Request for placement of balcony encroaching City right-of-way at 812/814 S. 8th St.

At the December 9, 2020 Board of Public Works meeting, the Board met to review request for placement of balcony encroaching in City Right-of-way at 812/814 S. 8th St.

NEW BALCONY FOR:

814 S. 8TH ST. • MANITOWOC, WI

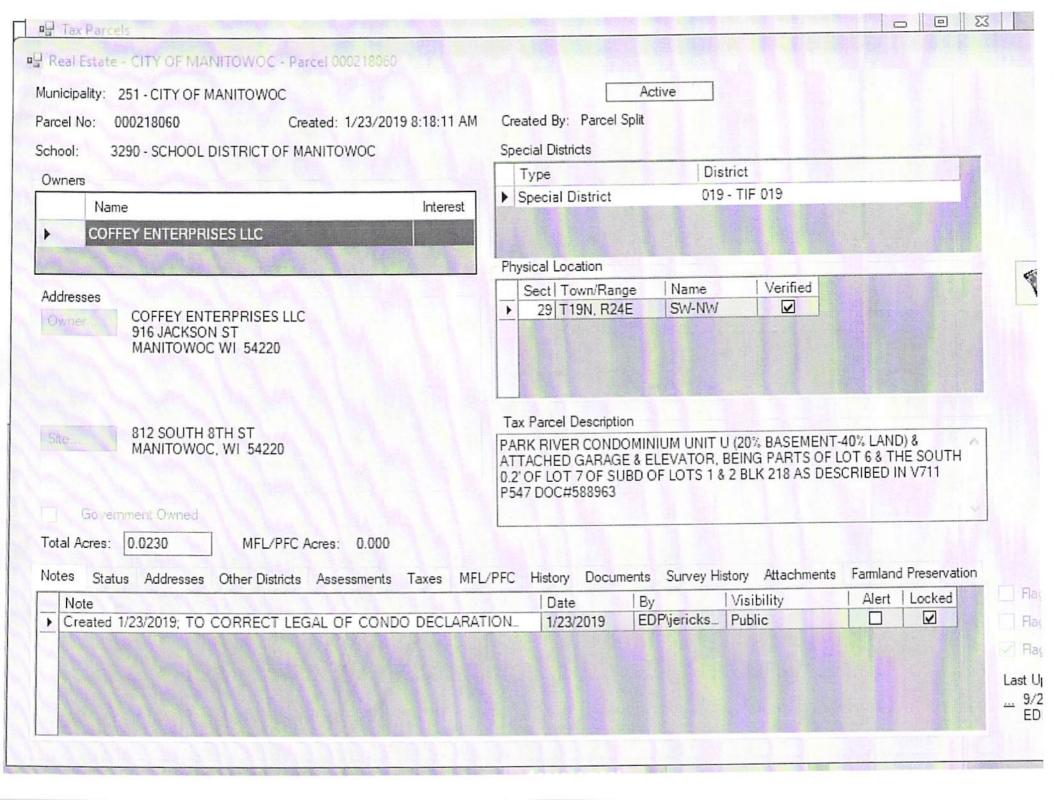
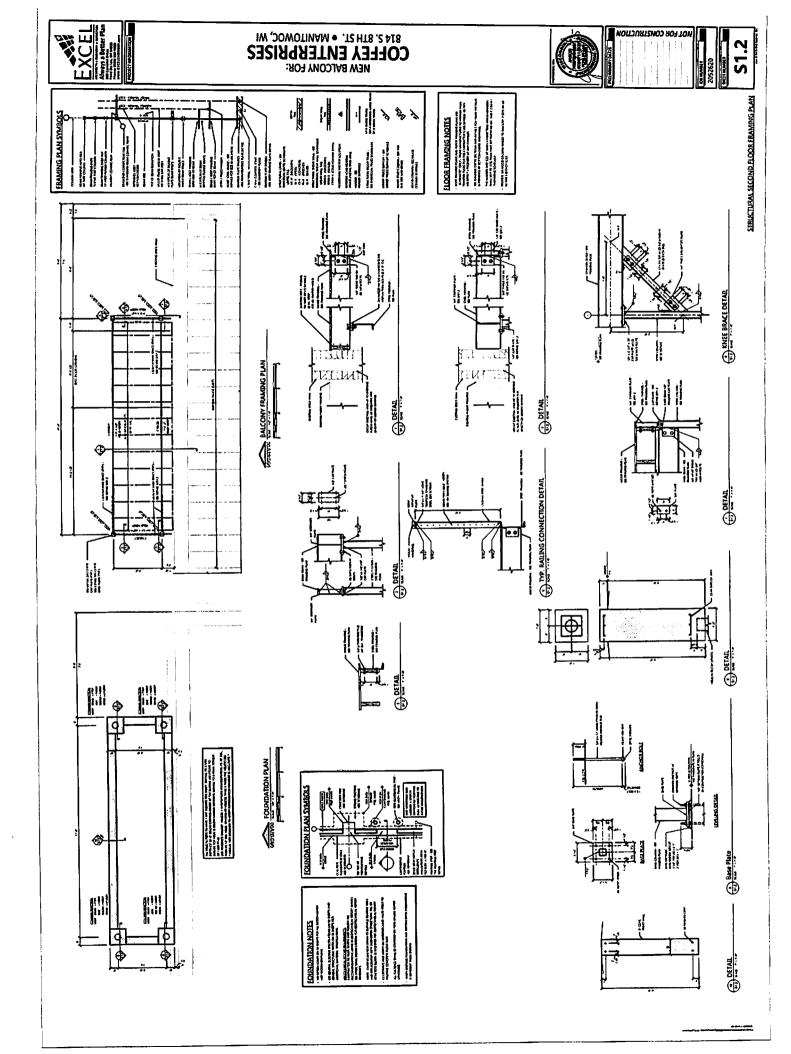
The sidewalk total width is only 10.5 feet from the face of building to the back of the curb.

There is a planter that will be in the way and also a tree and tree grate in the way to prevent going out and around the new columns. Are we going to remove one of the brand new planters and trees??

I believe that the only way this could be approved is if the new tree and planter are removed.

The columns are shown to be at 4 ft. on centers and are 1'-4" wide. That means the clearance between the 2 columns will only be 32 inches wide which is not an ADA complaint width. I thought that 40 inches was the bare minimum width with 48 inches preferred.

I do not know of any other locations on 8th St. or Washington St. that have columns like this in the heart of the sidewalk. The column that is to be located at 5 ft. from the face of building would be directly in the center of the mainline sidewalk.

"Director of Public Infrastructure Dan Koski indicated that City staff has no issue with the proposed balcony so long as it is on the north side of the building, and indicated that the property owner should work with the City Attorney's office for a Sidewalk Privilege Agreement. The property owner was also informed they would need to provide a legal description from a land surveyor for this property."
